COKE OVEN ENVIRONMENTAL TASK FORCE (COETF)

White Paper - Air Pollution Control Technology Review for Coke Battery Stacks and Pushing Emissions under EPA's Proposed Coke Ovens Risk & Technology Review

TRINITY CONSULTANTS

March 6 2024

Compliance Schedule Concerns for Combustion Stacks and Pushing Emissions

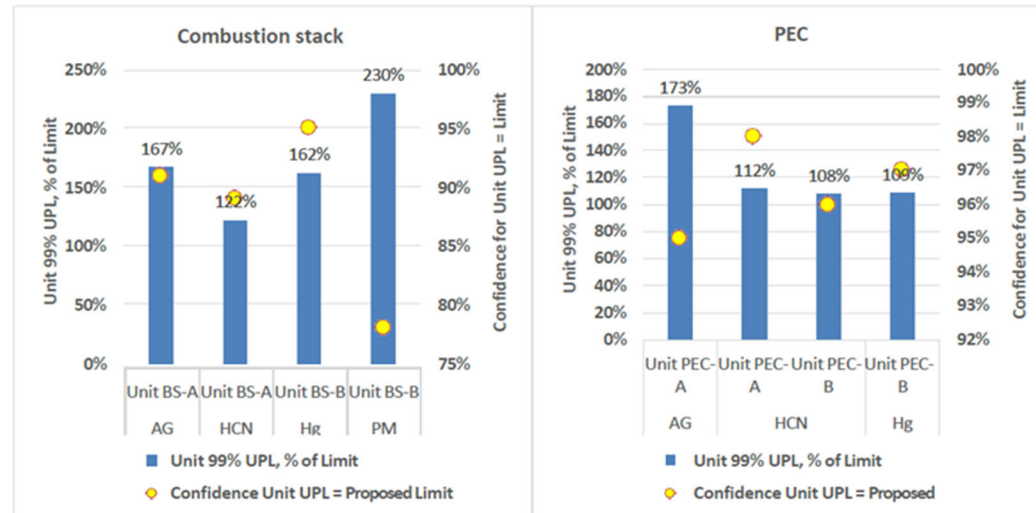
- COETF member companies have very little test data regarding the proposed standards for combustion stacks (AGs, HCN, Hg, and PM) and pushing emission control devices (PECs) (AGs, HCN, Hg, and PAH). Only 25% of combustion stacks and PECs were tested as part of the Section 114 ICRs.
- Available data exhibit substantial variability and show that the proposed standards are not consistently achievable for all pollutants without additional controls, operational changes, or both. The figures below show the 99% UPL for individual units (for units with 99% UPL exceeding the proposed standards). The confidence level lower than 99% at which the unit UPL equals the proposed standards also is shown. This analysis shows that additional controls and/or operational changes would be needed for these pollutants/sources:

- Combustion stacks –

- PM – New baghouse + fans (depending on PM size fraction)
- Acid Gases – Dry sorbent injection and new baghouse + fans
- HCN – No practical controls
- Hg – Activated carbon injection and new baghouse + fans

- Pushing –

- Hg – Activated carbon injection + existing baghouse
- Acid Gases – Dry sorbent injection + existing baghouse
- HCN – No practical controls
- Replacement of existing mobile traveling controls with new fixed controls (baghouse or scrubber) and traveling hood
